City of Greenville, North Carolina
BID #16-17-31

Request #: 1 Proposer: New Flyer of America Inc. RFP Section: Price Adjustments, Price Adjustments Page: 13	
Questions/clarification or approved equal: New Flyer requests approval to modify the following section to read: ... "Trucks and Bus Bodies." Notwithstanding anything else to the contrary contained herein, in the event that a price adjustment is required in respect of changes that are mandatory as a result of legislation or regulations that become effective after the date of the proposal submission, such price adjustment shall be negotiated in good faith by the City of Greenville and the Contractor. Revision provides for required price adjustments in event of changes in regulations.	
Agency action:	<input type="checkbox"/> Approved <input type="checkbox"/> See addendum <input checked="" type="checkbox"/> Denied <input type="checkbox"/> See response below
Agency response:

EMP Electric Cooling System-MH4 4GX4336DG

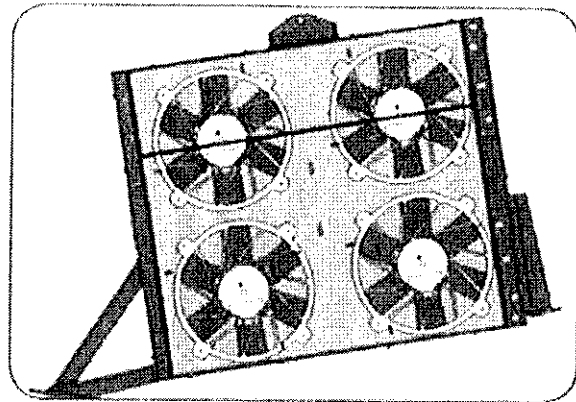
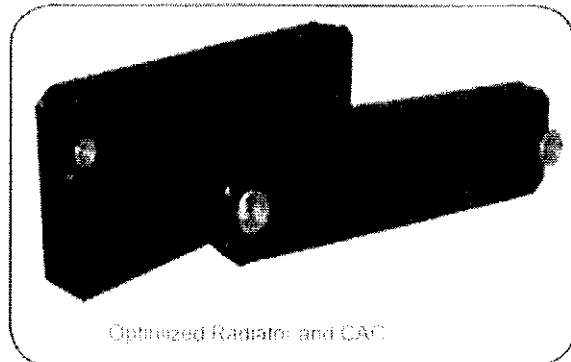
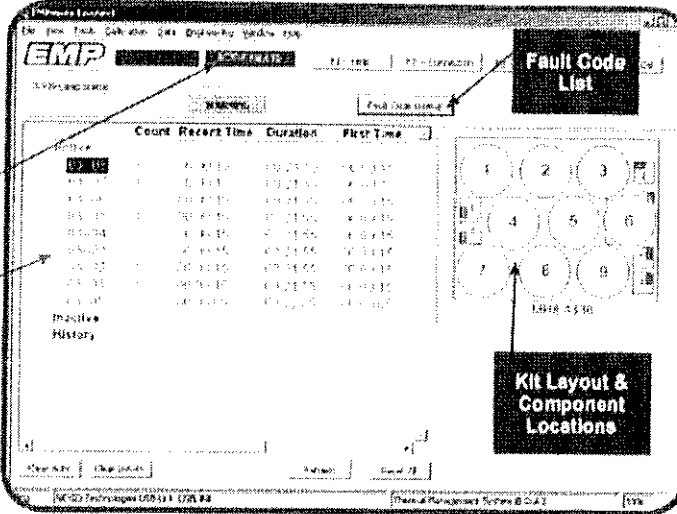
Request #: 15 Proposer: New Flyer of America Inc. RFP Section: COOLING SYSTEM. Page: 25	
Questions/clarification or approved equal: New Flyer requests approval to provide an EMP MH4 radiator with electric fans. New Flyer is proposing this system to lower Life-Cycle Costs as result of improved fuel economy, reduced maintenance and greater up-time. Please review Attachment E for additional information on the proposed cooling system	
Agency action:	<input checked="" type="checkbox"/> Approved <input type="checkbox"/> Denied <input type="checkbox"/> See addendum <input type="checkbox"/> See response below
Agency response:

Product Features

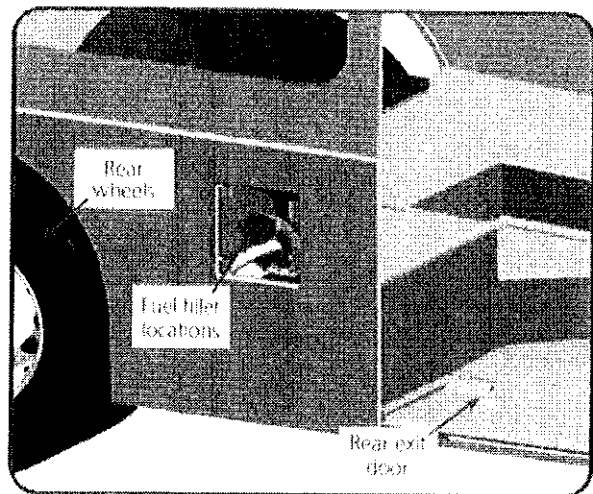
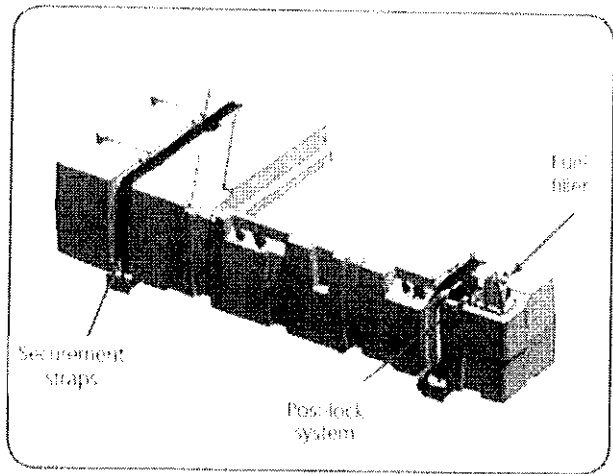
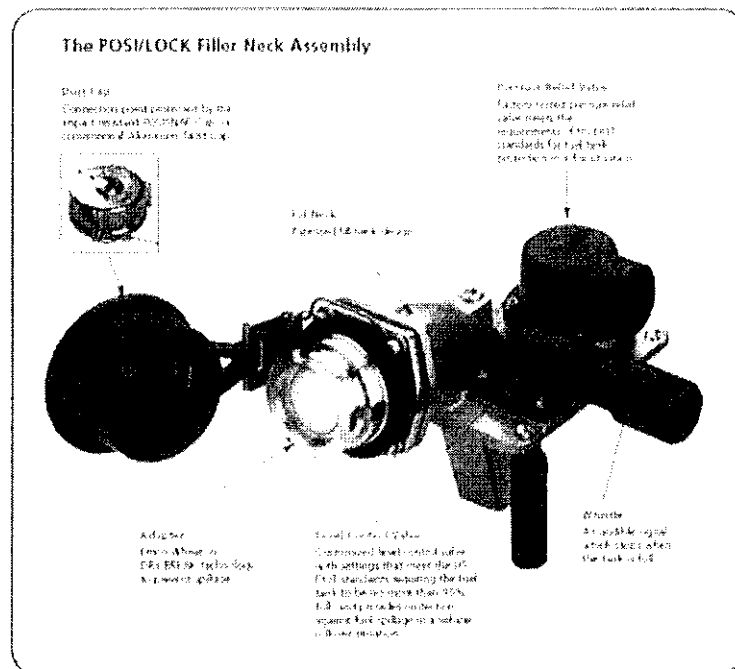
Request #: 25 Proposer: New Flyer of America Inc RFP Section: FUEL TANK (DIESEL), FUEL TANK (DIESEL) Page: 28	
Questions/clarification or approved equal: New Flyer requests approval to provide a fuel tank constructed of cross-linked polyethylene which still contains the necessary baffles required to control the moving of the liquid inside the tank. The Xclesior(r) platform was designed with a guideline to reduce weight and improve fuel efficiency and choosing the polyethelene fuel tank serves that goal. The entire fuel system is compliant to APTA Whitebook guidelines and the tank comes with a 1yrs/50,000miles warranty Please refer to Attachment D for additional information on the proposed Diesel Fuel Tank	
Agency action:	<input checked="" type="checkbox"/> Approved <input type="checkbox"/> Denied <input type="checkbox"/> See addendum <input type="checkbox"/> See response below
Agency response:

Fuel System - Compressed Natural Gas (CNG)

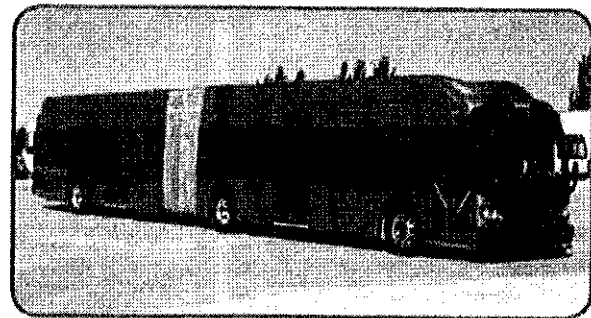
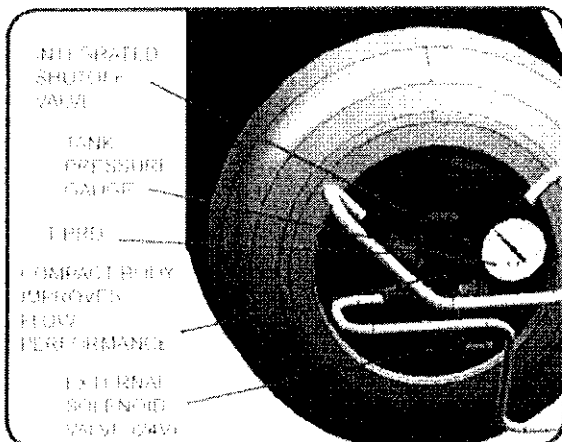
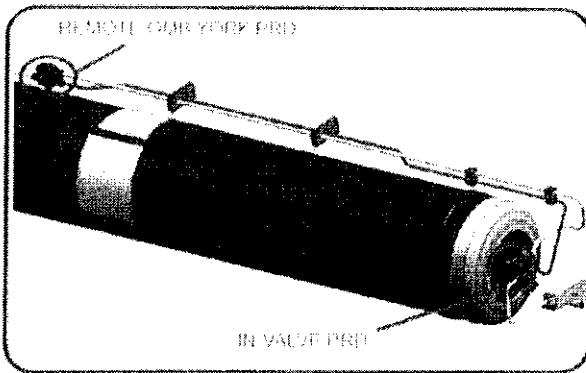
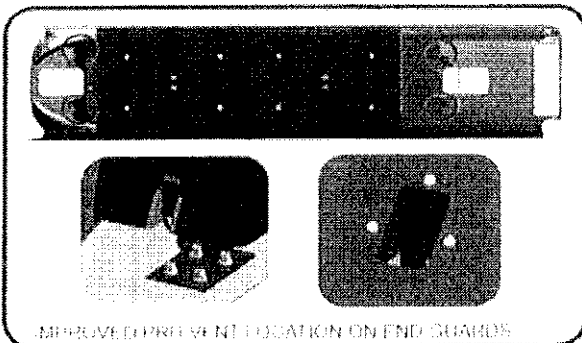
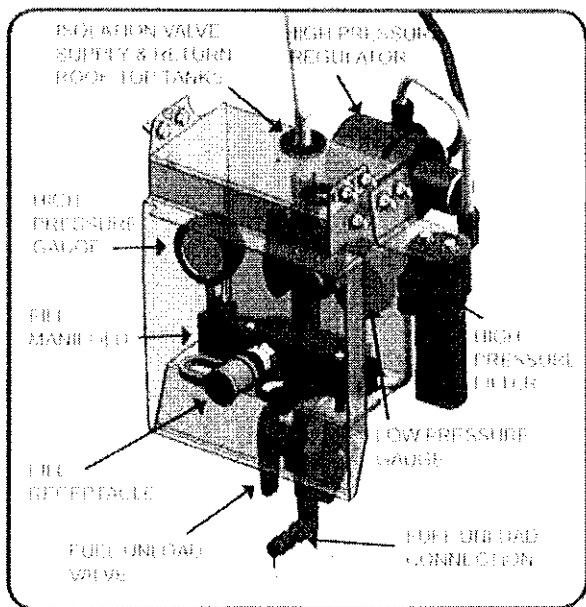
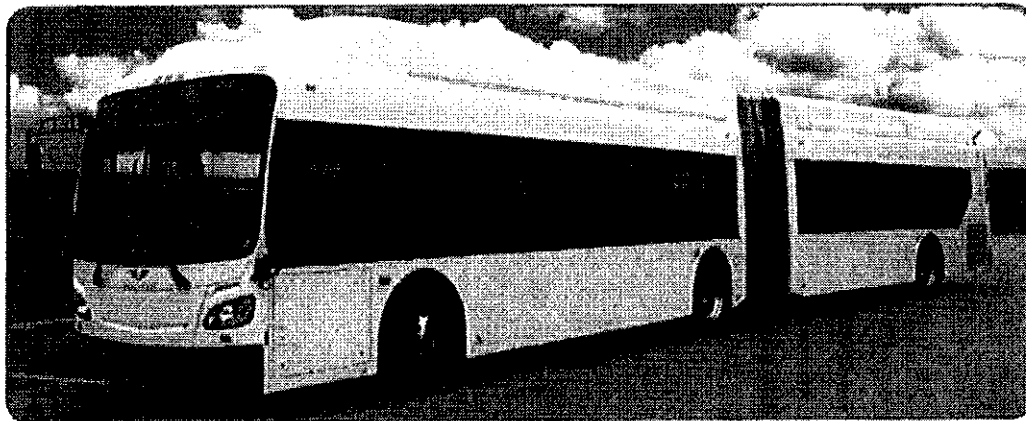
Request #: 28 Proposer: New Flyer of America Inc. RFP Section: FUEL TANK (CNG). Storage Tanks Page: 29	
Questions/clarification or approved equal: New Flyer requests approval to provide Type 4 All Carbon Fiber tanks manufactured by Agility Fuel Solutions. Please refer to Attachment C for additional information	
Agency action:	<input checked="" type="checkbox"/> Approved <input type="checkbox"/> Denied <input type="checkbox"/> See addendum <input type="checkbox"/> See response below
Agency response:
